Technical Service Bulletin

No.LTB00097

Subject/Concern: Discovery 3/LR3, Range Rover Sport - Minor Steering Column Knock
--

Models:		
Discovery 3 / LR3		VIN-range: 000303-444606
Range Rover Sport (LS)		VIN-range: 900109-122778

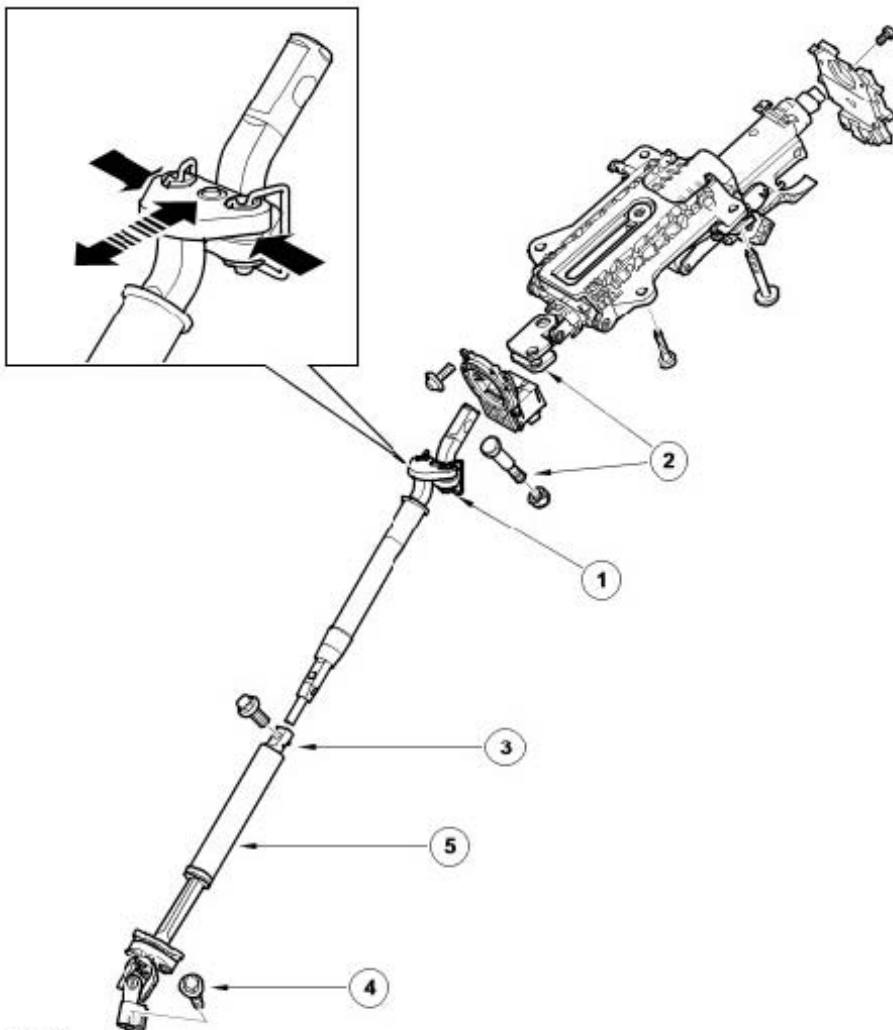
- 1 Examine the steering column intermediate shaft 'decoupler' (item 1 in illustration) integrity, ensuring that the steel and rubber washers are correctly located. 1 . If excessive movement exists at the decoupler or the washers are not correctly located, renew the intermediate shaft.

- 2 Check the steering column universal joint to upper intermediate shaft connection (item 2 in illustration) retaining torque; 30Nm (22lb-ft).
- 3 Check for movement at the intermediate to lower shaft joint (item 3 in illustration). 1 If movement exists, renew the bolt and tighten to 30Nm (22lb-ft).

- 4 .
4 Check for movement at the lower shaft universal joint to steering gear connection (item 4 in illustration). 1 If movement exists, renew the retaining bolt and tighten to 30Nm (22lb-ft).

- 5 . Check for movement at the lower shaft sliding joint (item 5 in illustration).
1 If movement exists, renew the lower shaft.
